**PROPOSED SOCIAL WELFARE FACILITY (RESIDENTIAL CARE HOME FOR PERSONS WITH DISABILITIES) IN "VILLAGE TYPE DEVELOPMENT" ZONE ON APPROVED NAM SANG WAI OUTLINE ZONING PLAN NO. S/YL-NSW/10 AT LOTS 3669 S.A RP (PART), 3669 S.B RP (PART), 3670 RP (PART) AND ADJOINING GOVERNMENT LAND IN D.D.104, NAM SANG WAI, YUEN LONG**

**Town Planning Application No. A/YL-NSW/348 - Submission of Further Information (2)**

**Response-to-Comment Table**

**FIGURE 2.1**  
**LOCATION OF REPRESENTATIVE AIR**  
**SENSITIVE RECEIVERS**

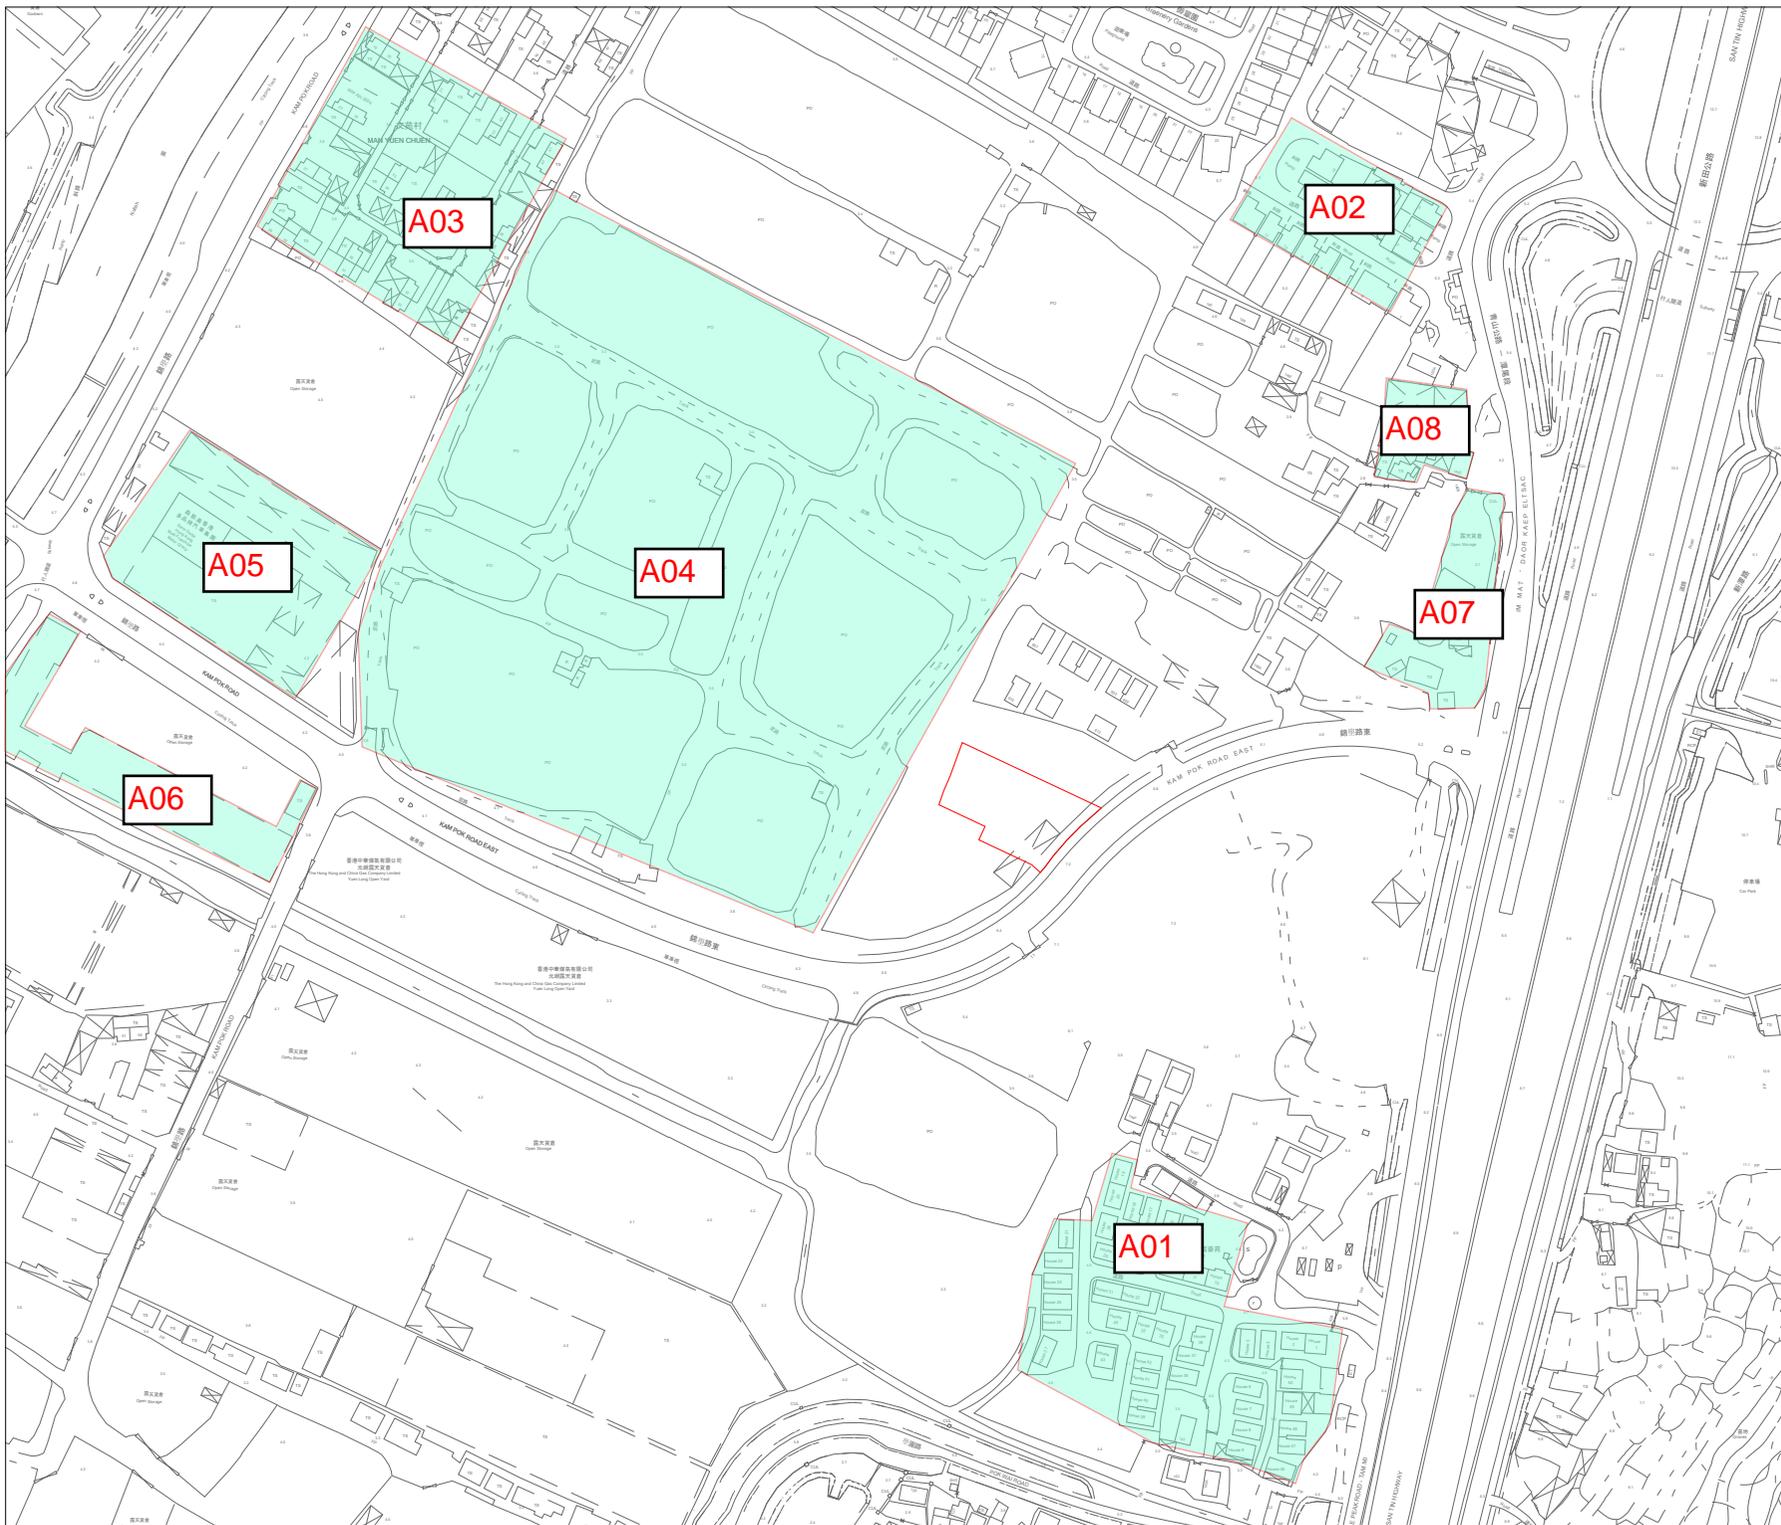
a. Section 2.3.1, Table 2.3 and Figure 2.1 - Please note that not only the domestic premises are the ASRs, some places/premises such as factory and workshop may also be the ASRs. Based on the desktop review, there are some areas in the vicinity of the project site which have been used for workshops/open storage, etc. Please review the potential existing/planned ASRs within the assessment area with reference to the Determination of ASR under the EIAO-TM and update as appropriate.	More ASRs have been identified in Table 2.3 and Figure 2.1. For other areas mainly for open storage use where long duration of exposure to air pollutants is not expected are, therefore, not considered as ASR.
<b>4. Sections 2.4.1 and 2.4.2</b>

**FIGURE 2.2  
BUFFER DISTANCES**

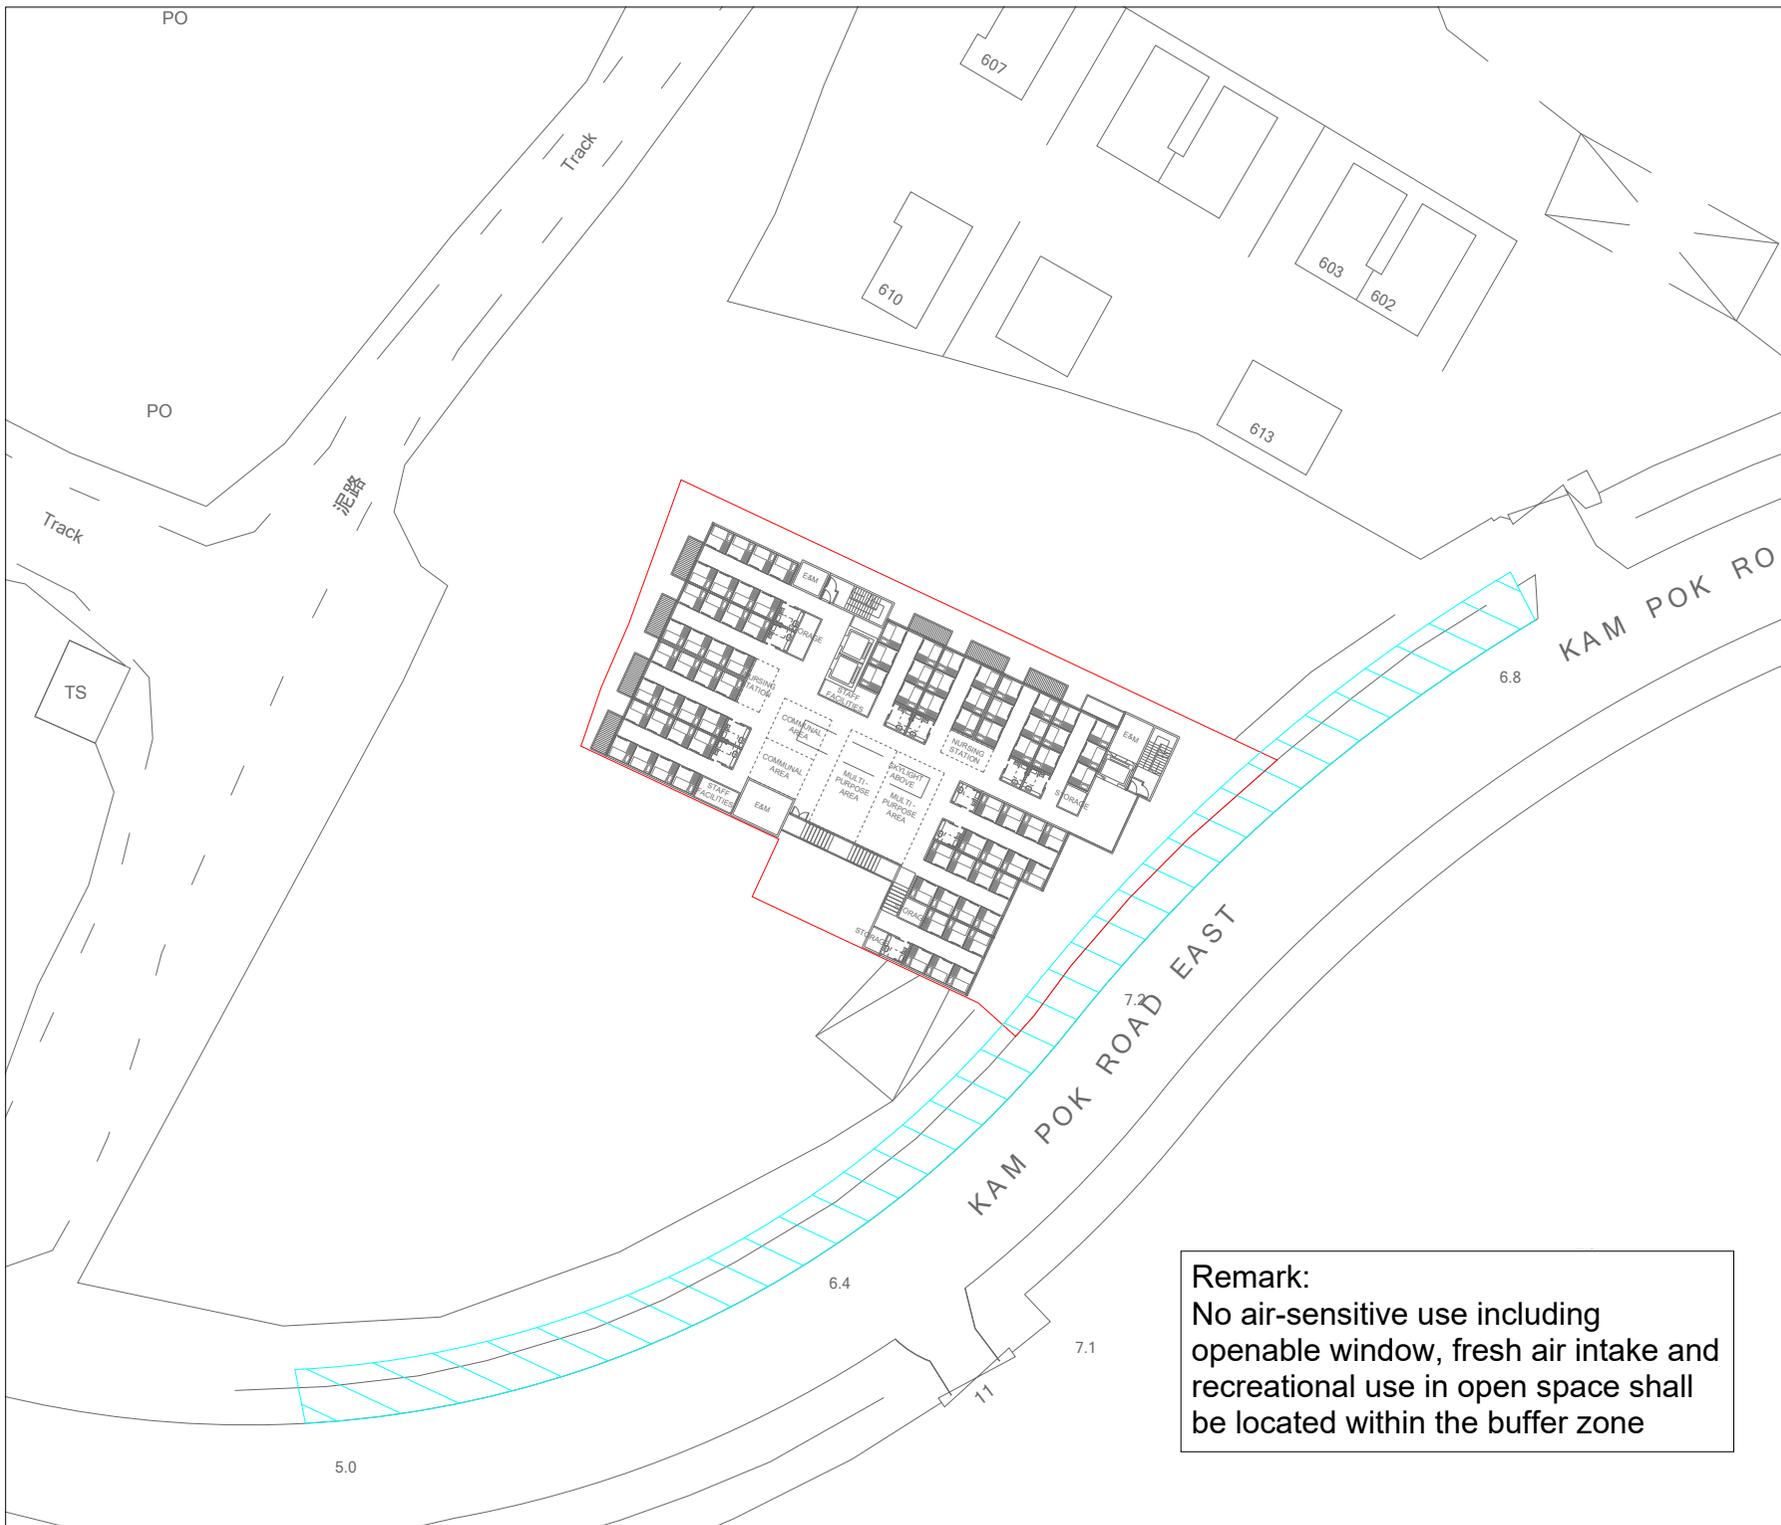
a. Please supplement this section by incorporating the Comments #8 and #9 above.	The section is revised accordingly.
<b>12. Figure 2.2</b>	
a. The buffer distance should be measured from the edge of road kerb. Please update and present the buffer zone appropriately.	Figure 2.2 is revised accordingly.

b. Please show the road name of Kam Pok Road East clearly in the figure.	Figure 2.2 is revised accordingly.
c. Please add a remark “No air-sensitive use including openable window, fresh air intake and recreational use in open space shall be located within the buffer zone”.	Figure 2.2 is revised accordingly.
<b><u>Email dated 18<sup>th</sup> July 2025 refers:</u></b>	
<b><u>Comment from the Director of Environmental Protection</u></b>	
<b><u>(Please refer to Appendix 1 for the Revised Environmental Assessment)</u></b>	
<b><u>Comments on the Noise Chapter of the Environmental Assessment:</u></b>

**Remark:**  
 No air-sensitive use including openable window, fresh air intake and recreational use in open space shall be located within the buffer zone

**FIGURE 3.3  
LOCATION OF PROPOSED ACOUSTIC  
WINDOW**

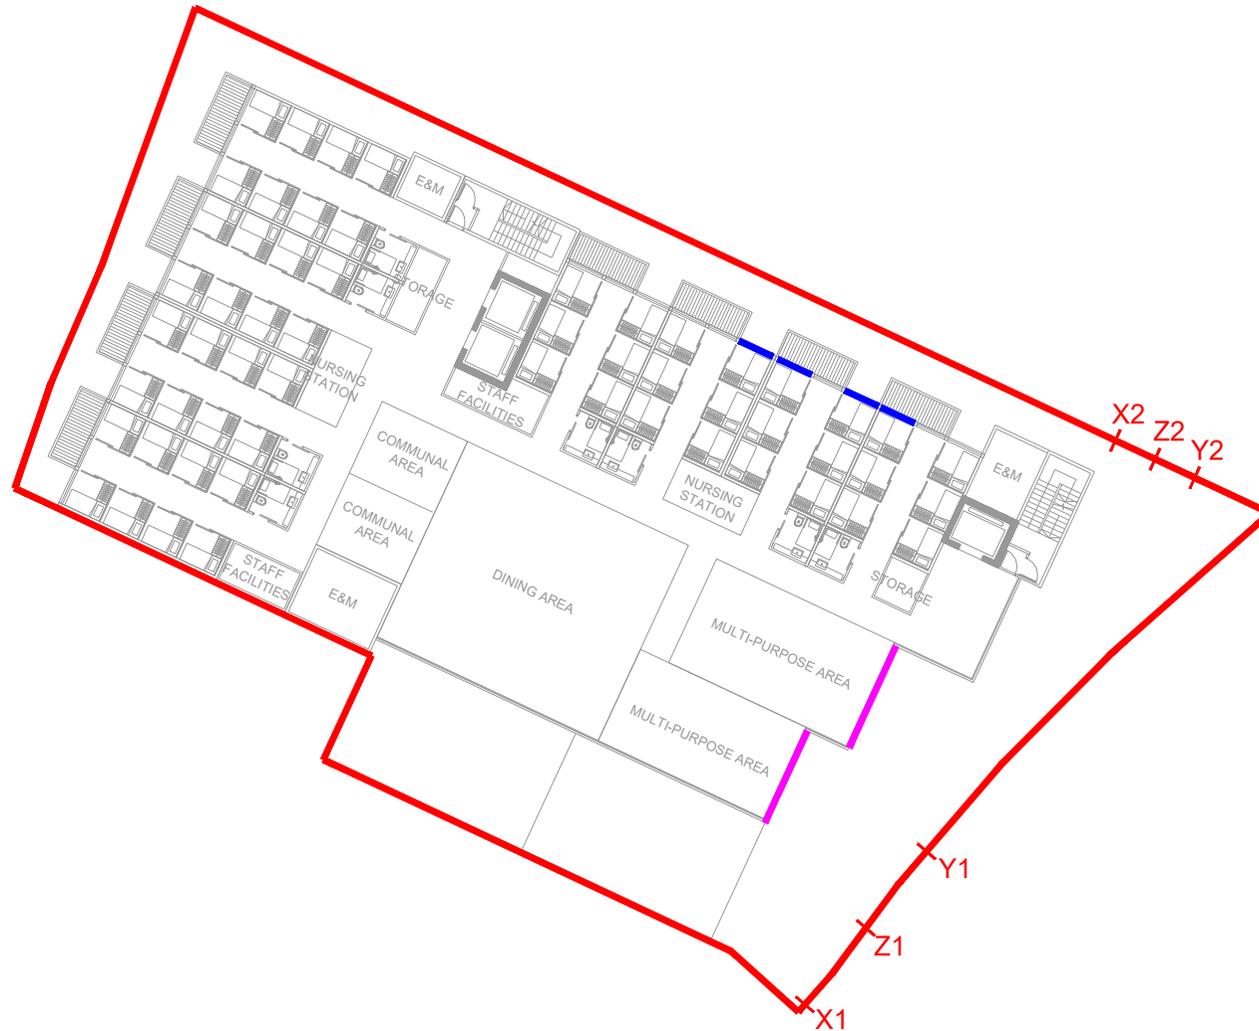
9. Figure 3.3 i. For 1st floor plan, the legend for blue line is missing, please indicated what the blue line means. Is it the acoustic window?	Figure 3.3 is revised for easy reference.

Figure No. **2.7** Revision **B**

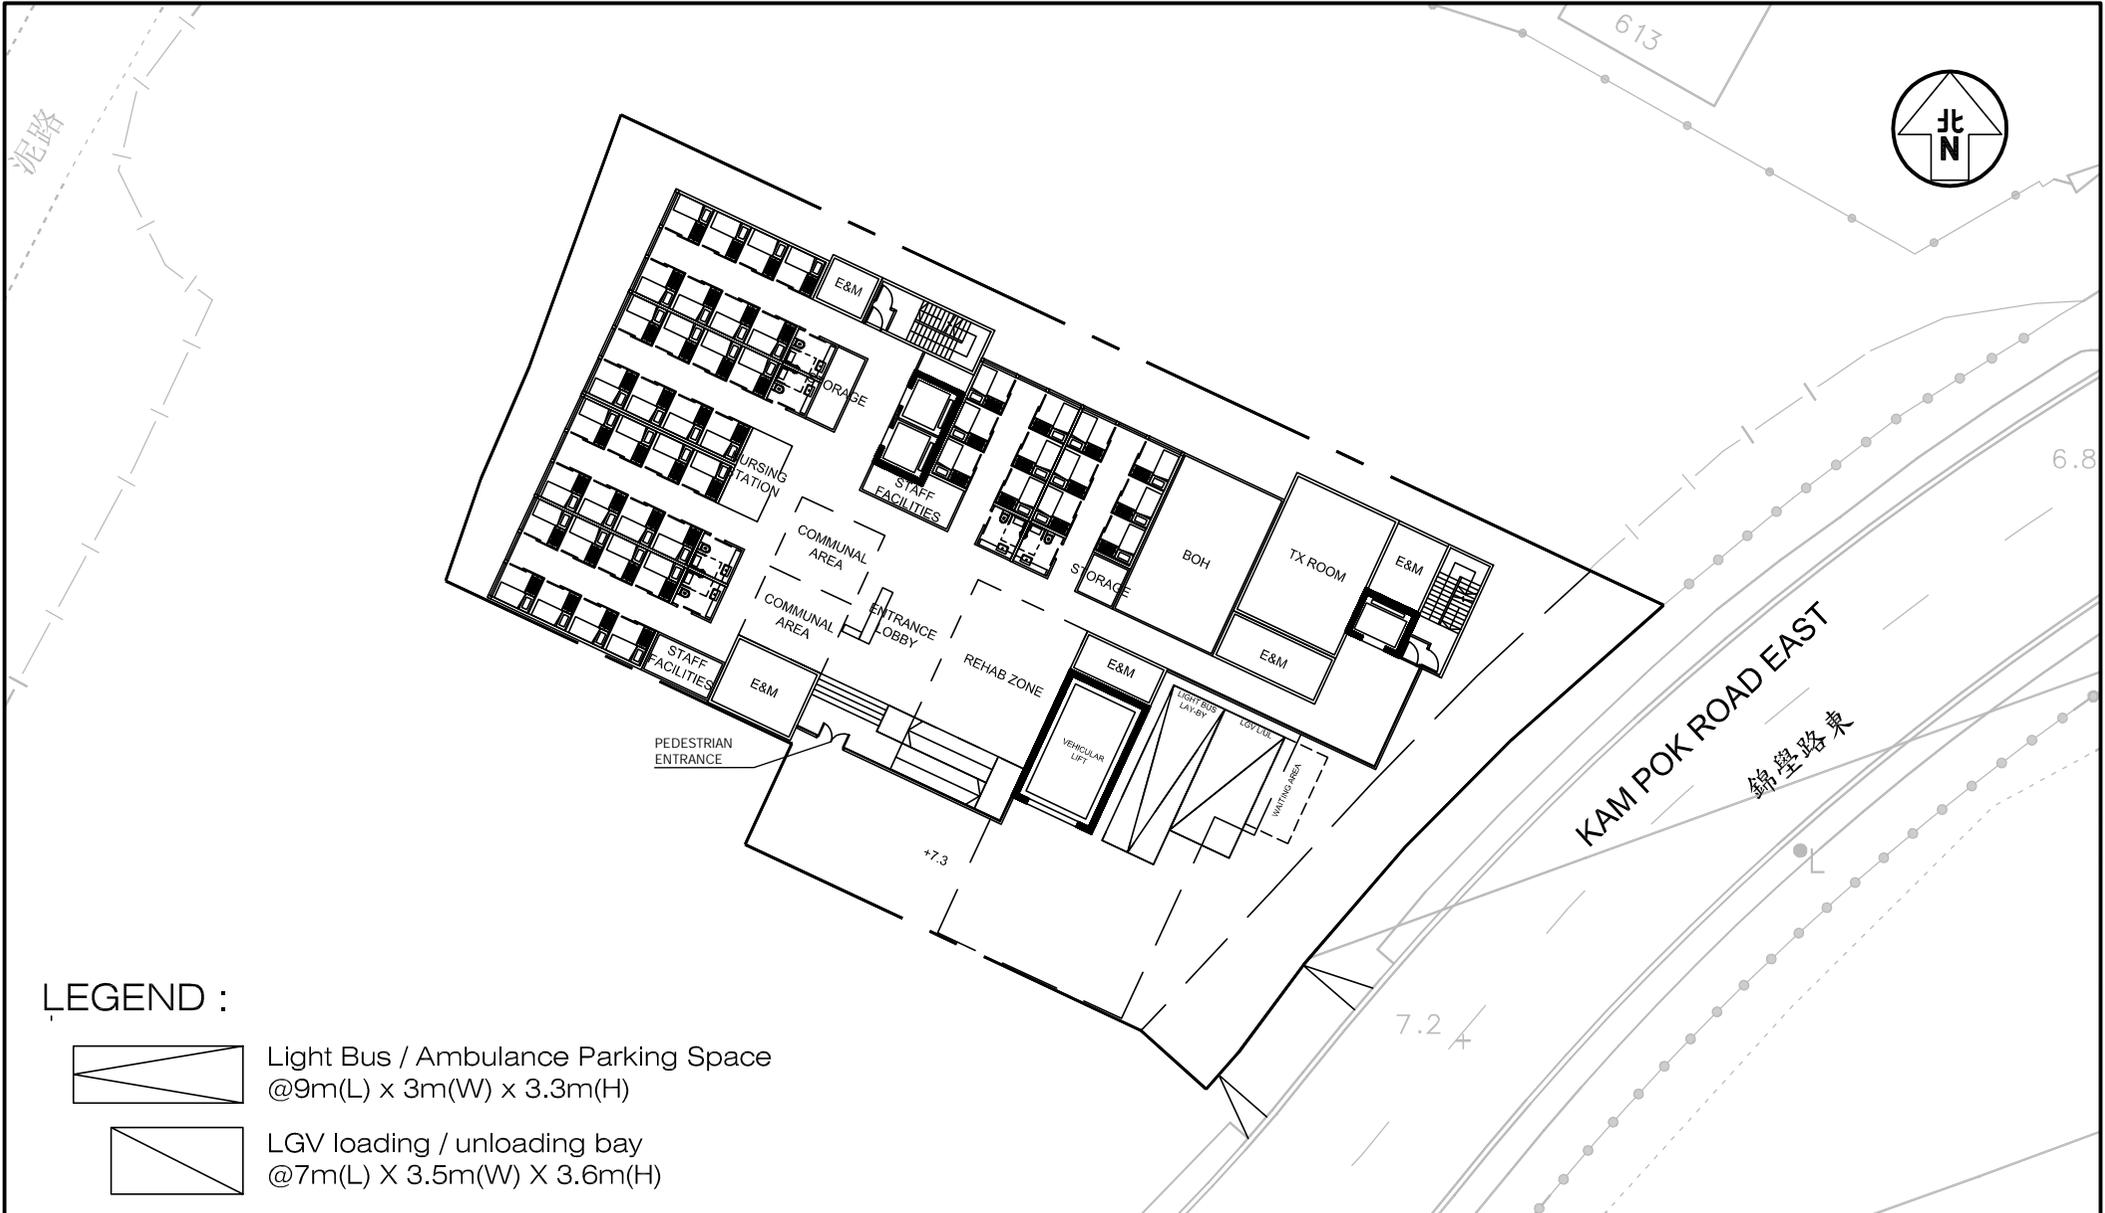
12. Please provide a plan showing the pedestrian routing to the nearby franchised bus stop (both Yuen Long and Sheung Shui bound). Please specify the corresponding walking distance as well;	Noted. Please refer to Figure 2.7 in the revised TIA for the pedestrian route to the nearby franchised bus stops.
